Work Order ID 155852

DART SERVICE INSTRUCTION

TO AMEND INSTALLATION INSTRUCTIONS IIN-D117-762 REV. E AND INSTRUCTIONS FOR CONTINUED AIRWORTHINESS ICA-D117-762 REV. 4

A	NEW ISSUE	RF	17.01.09
REV.	DESCRIPTION	BY	DATE
DESIGN	RF	DART AEROSPACE, LTD EUGENE, OR	
DRAWN	RF		
CHECKED	WK	DRAWING NO.	REV.A
MFG. APPR.	N/A	DSI 9771	SHEET 1 OF 2
APPROVED	HS	TITLE	SCALE
DE APPR.		GHL UPGRADE KIT	NTS
DATE	17.01.09	COPYRIGHT ©2017 BY DART AEROSPACE USA, INC THIS DOCUMENT IS PRIVATE AND CONFIDENTIAL AND IS SUPPLIED ON THE EXPRESS CONDITION THAT IT IS NOT TO BE USED FOR ANY PURPOSE OR COPIED OR COMMUNICATED TO ANY OTHER PERSON WITHOUT WRITTEN PERMISSION FROM DART AEROSPACE, LTD.

FIGURE 1 - GHU UPGRADE INSTALLATION

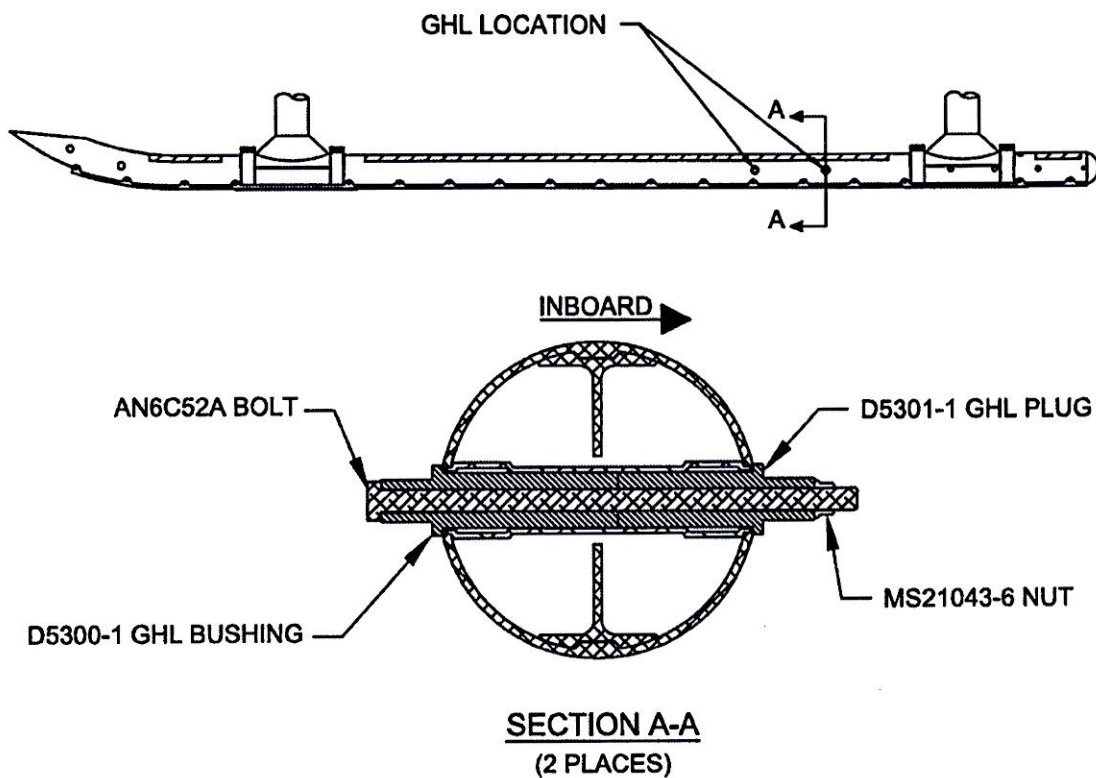
The purpose of this Dart Service Instruction (DSI) is to replace the ground handling lugs (D3864-1 Bushings, AN6C51A Bolts and MS21043-6 Nuts) on the D117-762-XXX Skid tubes with a structurally superior lug design (D5300-1 Bushings, D5301-1 Plugs, AN6C52A Bolts, MS21043-6 Nuts) as shown in Figure 1. The new hardware will be included in D117-762-011 @ CHG 004 and subsequent.

- 2.1 Loosely install (qty 2) D5300-1 GHL Bushing & (qty 2) D5301-1 GHL Plug wet with Proseal 890 or MIL-S-8802 Class B2 Sealant in location shown in Figure 1.
- 2.2 Install (qty 2) AN6C52A Bolts and (qty 2) MS21043-6 Nuts in accordance with Figure 1. Clean up squeezed out Proseal and apply fillet seal around D5300-1 & D5301-1.
- 2.3 Torque AN6C52A Bolts 160 - 190 in-lbs (18.1 - 21.5 N-m).

ITEM	QTY -011	PART NUMBER	DESCRIPTION
	X	D117-762-011	SKIDTUBE INSTALLATION
50	2	AN6C52A	BOLT
51A	2	D5300-1	GHL BUSHING
51B	2	D5301-1	GHL PLUG
52	2	MS21043-6	NUT

ITEM	QTY -011	PART NUMBER	DESCRIPTION
	X	D117-762-011	SKIDTUBE INSTALLATION
50	2	AN6C51A	BOLT
51	4	D3864-1	BUSHING
52	2	MS21043-6	NUT

FIGURE 1 - GHL UPGRADE INSTALLATION

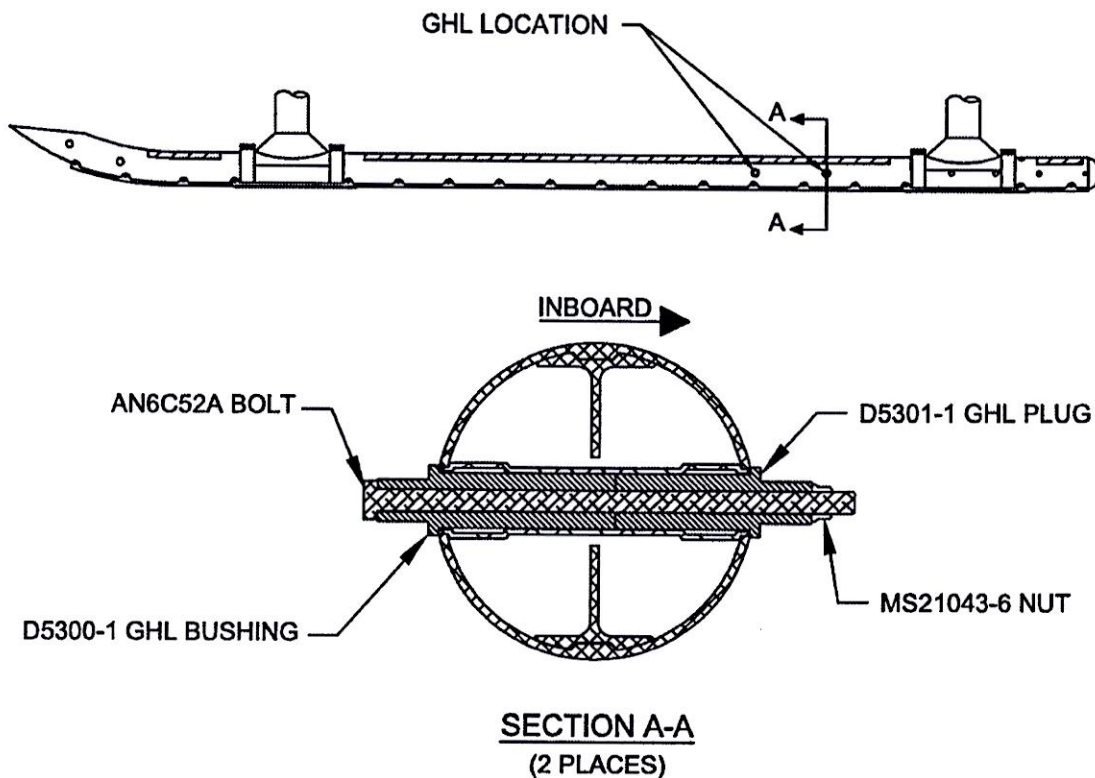
The purpose of this Dart Service Instruction (DSI) is to replace the ground handling lugs (D3864-1 Bushings, AN6C51A Bolts and MS21043-6 Nuts) on the D117-762-XXX Skid tubes with a structurally superior lug design (D5300-1 Bushings, D5301-1 Plugs, AN6C52A Bolts, MS21043-6 Nuts) as shown in Figure 1. The new hardware will be included in D117-762-011 @ CHG 004 and subsequent.

- 2.1 Loosely install (qty 2) D5300-1 GHL Bushing & (qty 2) D5301-1 GHL Plug wet with Proseal 890 or MIL-S-8802 Class B2 Sealant in location shown in Figure 1.
- 2.2 Install (qty 2) AN6C52A Bolts and (qty 2) MS21043-6 Nuts in accordance with Figure 1. Clean up squeezed out Proseal and apply fillet seal around D5300-1 & D5301-1.
- 2.3 Torque AN6C52A Bolts 160 - 190 in-lbs (18.1 - 21.5 N-m).

ITEM	QTY -011	PART NUMBER	DESCRIPTION
	X	D117-762-011	SKIDTUBE INSTALLATION
50	2	AN6C52A	BOLT
51A	2	D5300-1	GHL BUSHING
51B	2	D5301-1	GHL PLUG
52	2	MS21043-6	NUT

ITEM	QTY -011	PART NUMBER	DESCRIPTION
	X	D117-762-011	SKIDTUBE INSTALLATION
50	2	AN6C51A	BOLT
51	4	D3864-1	BUSHING
52	2	MS21043-6	NUT
